MOUNTAIN LAKE DAM

NDI ID NO. PA-00546

PHASE I INSPECTION REPORT
NATIONAL DAM INSPECTION PROGRAM

JUNE 1980

SUBJECT MOUNTAIN LAKE DAM FILE NO. 8202
CROSS SECTION OF EMBANKMENT SHEET NO. 2 OF 2 SHEETS
FOR _____
COMPUTED BY DLE DATE 4-30 CHECKED BY _____ DATE _____

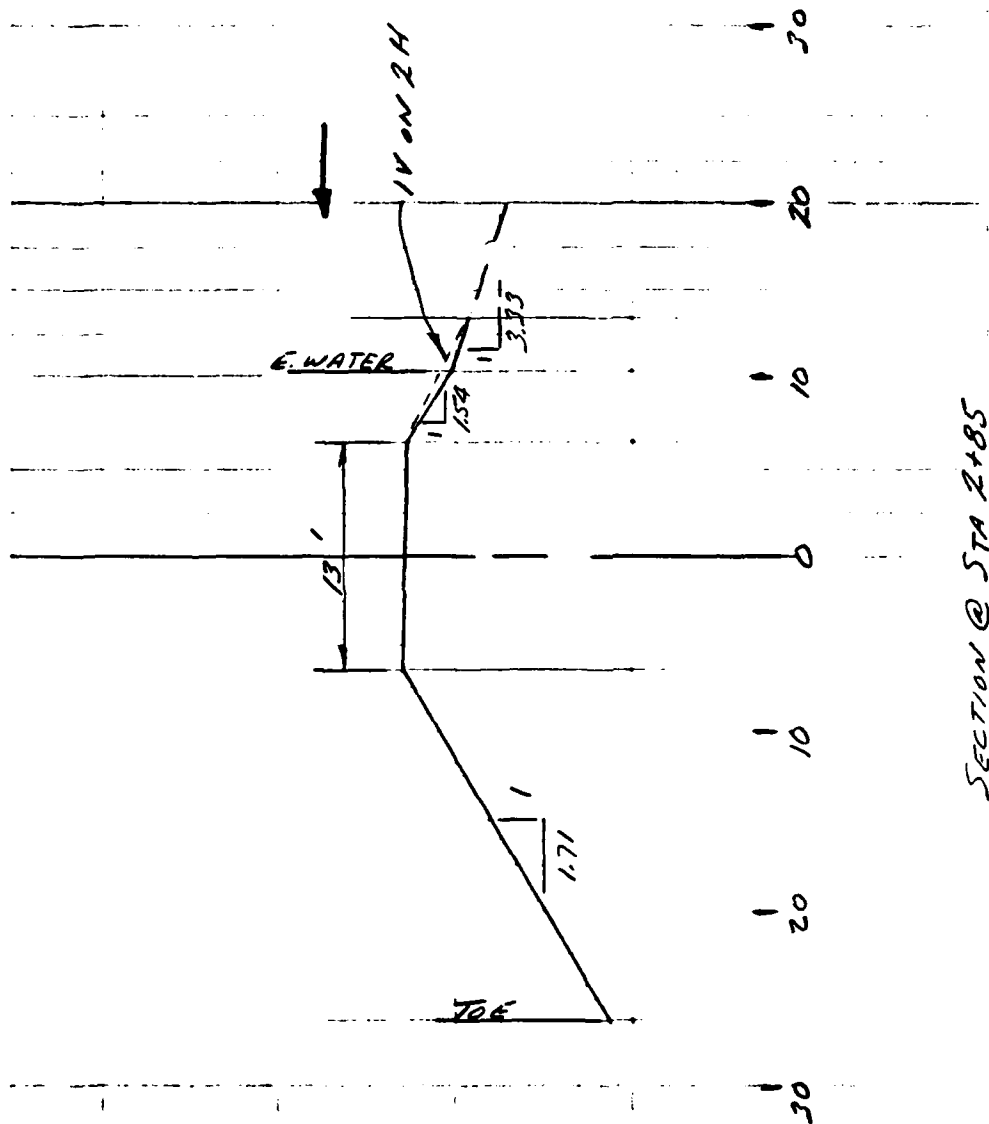
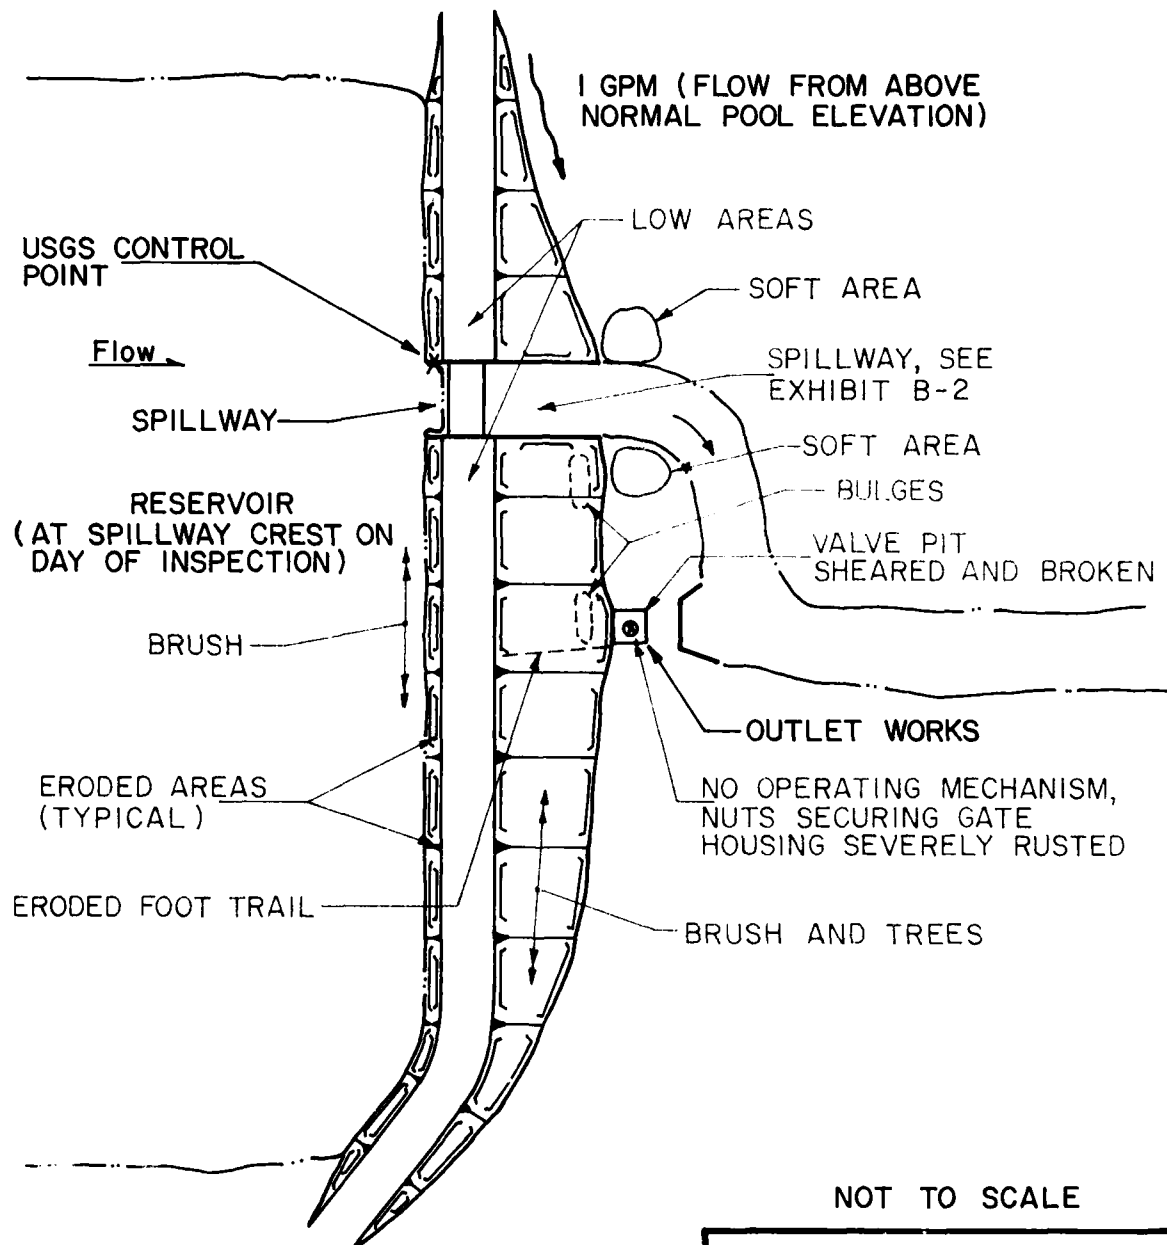
THE UPPER PART OF THE UPSTREAM SLOPE AND THE
DOWNSTREAM SLOPE ARE STEEPER THAN THE
REPORTED DESIGN.

EXHIBIT B-1

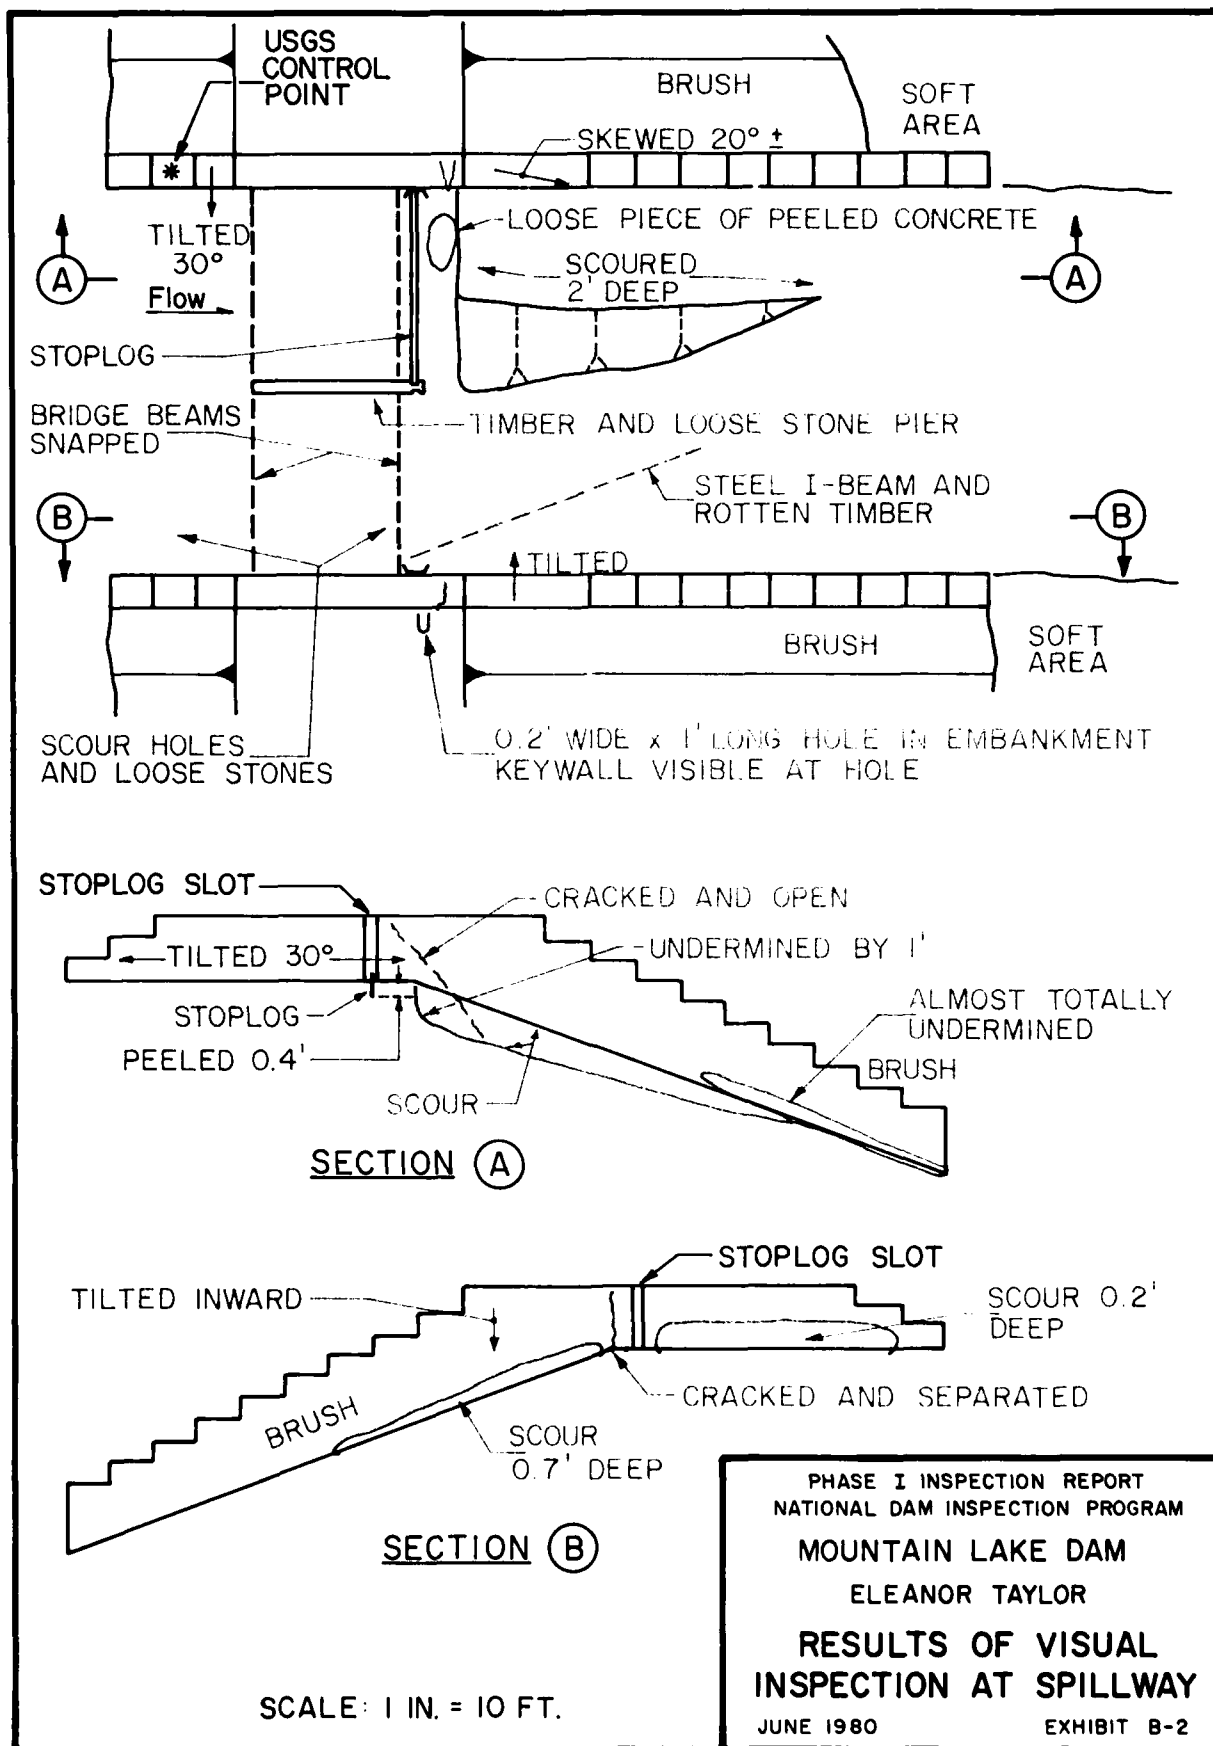
a. General. The overall appearance of the dam is poor. Deficiencies were observed as noted below. A sketch of the dam with the locations of deficiencies is presented on Exhibits B-1 and B-2 in Appendix B. Survey information acquired for this Report is summarized in Appendix B. Datum for the survey was taken at the USGS horizontal control point at the dam, Elevation 1989.0, as shown on USGS mapping. On the day of the inspection, the pool was at the spillway crest level.

At the right spillway wall, adjacent to the crest, there is a concrete keywall. A 1-foot length of the embankment at this area is open to a width of 0.1 to 0.2 foot. The keywall is visible in the opening. Brush and trees are growing in and adjacent to the spillway. The spillway is shown on Exhibit B-2.

F. Spillway Bridge

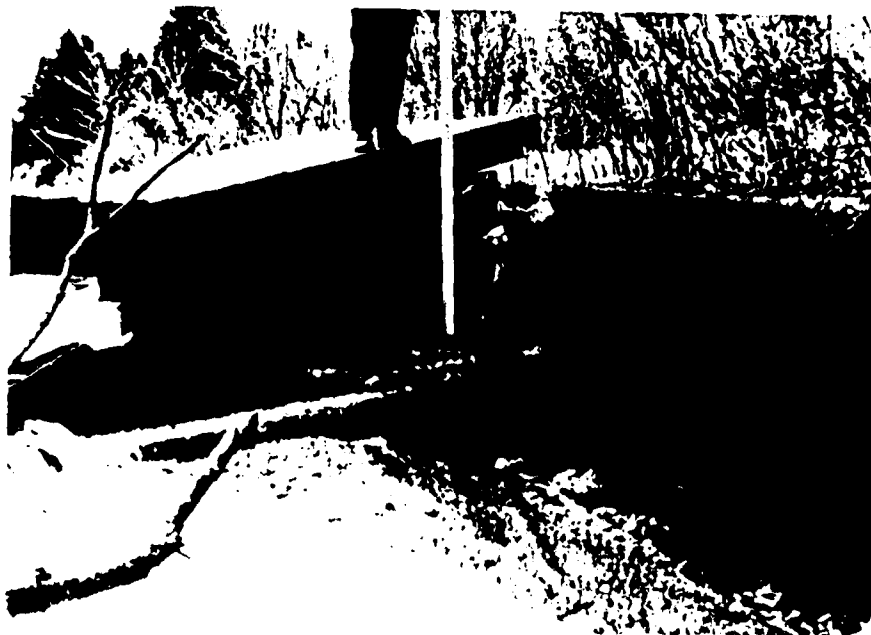
The spillway is in very poor condition. The wooden beams supporting the timber spillway bridge have snapped, leaving the bridge bowed (Photograph F). The bridge is partially supported in the center by a pier constructed of timber and loose stones. To the left of the pier, a 0.9-foot high stoplog extends across the crest (Photograph H). The top 0.4-foot thick layer of concrete has peeled off the crest to the left of the pier. Portions of the peeled concrete lie loosely on the crest. To the right of the pier, a steel I-beam and a rotten log lie skewed to the crest (Photograph G). Upstream from the crest, the left spillway wall is tilted about 30° towards the centerline of the spillway. At the crest, the left wall is cracked through and open. Just downstream, the wall is skewed about 20°. Further downstream, the wall is almost totally undermined along its entire length. The right wall is in slightly better condition, although the part that is just downstream from the crest is skewed about 10° and tilted inward. The right wall upstream of the crest is scoured from 0.1 to 0.2 foot deep. Downstream of the crest, the scoured area is about 1.2 feet high and 0.7 foot deep. At the crest, the wall is cracked and separated.

(1) Remove the spillway bridge. Also remove brush and debris from the spillway. Until the recommendations below are completed, provide temporary measures to ensure the structural stability of the spillway.
